NUREG-0847
Supplement No. 15

Safety Evaluation Report

related to the operation of
Watts Bar Nuclear Plant,
Units 1 and 2
Docket Nos. 50-390 and 50-391

June 1995

Figure 6.1 Divider Barrier Seal

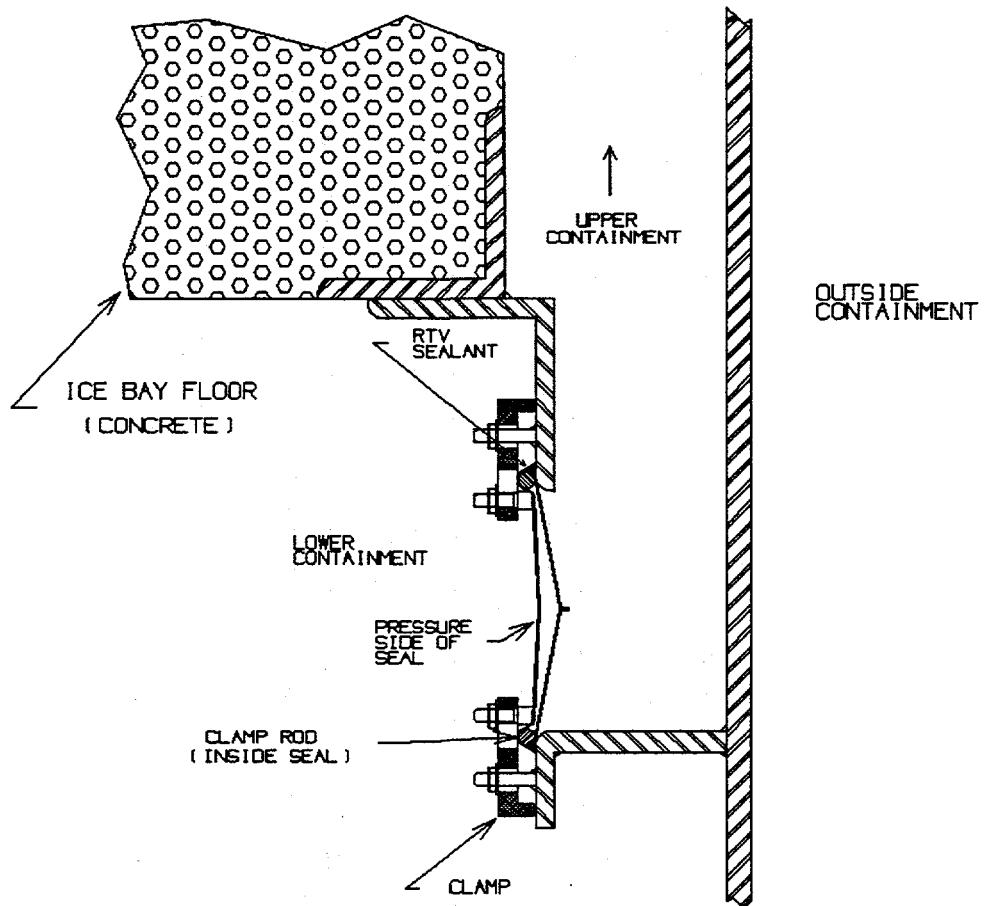
The cold-splice adhesive used in the installation of the material that replaces the removed specimens has been found to provide sufficient strength for LOCA integrity in the tested (unaged) conditions, but to be vulnerable to heat aging. As indicated above, its condition must, therefore, be monitored through additional unique periodic surveillance testing. Peel tests would be performed on test specimens at 18-month or 36-month intervals, the interval for each joint location being dependent on the initial peel test result for that location. The peel test procedure and recommended test intervals are described in Presray Report No. PR16550, "Procedure for Cold Bonding Divider Barrier Seal Splice Joints." The staff reviewed the report while on site on February 23, 1995. The test specimens are not part of the actual divider barrier seal. They are specimens of material removed during the repair and are located near the seal at each splice joint.

The staff reviewed the information submitted by the applicant and concluded that a revised divider barrier seal surveillance program is appropriate for Watts Bar Unit 1. The tensile testing may be deleted based on the additional testing that demonstrates that the seal material, including the original vulcanized joints, is qualified for a 40-year life and DBA-LOCA. Additional peel tests on test coupons will be performed periodically to monitor the condition of the adhesive used in the cold-bond/bolted splices. The test frequency for the peel tests will be as recommended by the vendor.
